Dual-Core Intel[®] Xeon[®] Processor 7100 Series

Specification Update

October 2006

Figure 3-5. Processor Bottom-Side Markings

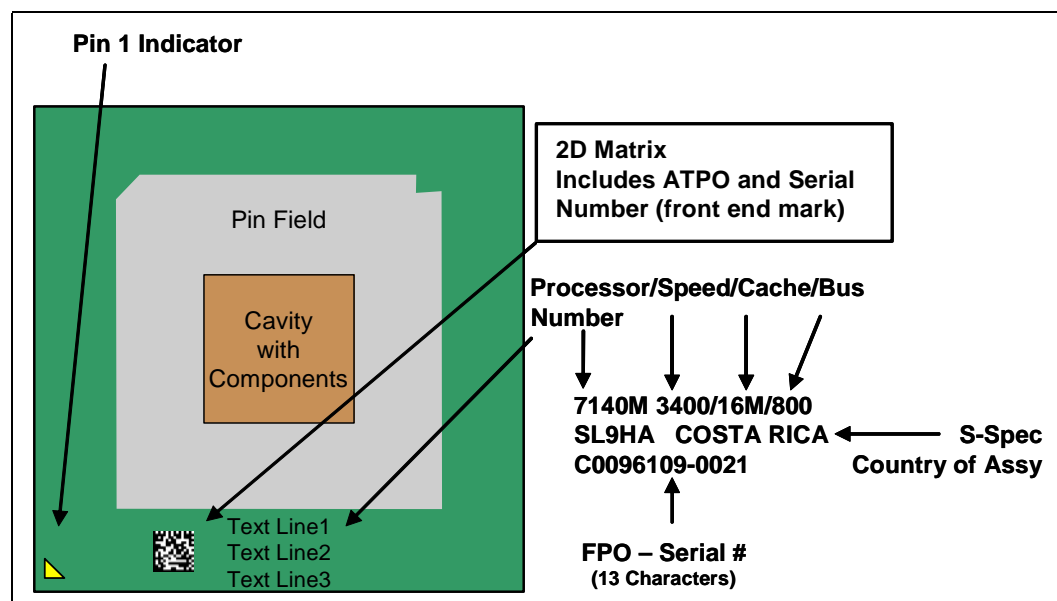
1. 2D Matrix Added to the Bottom Side Laser Mark

Figure 3-5. Processor Bottom-Side Markings has been updated to include a 2D Matrix.
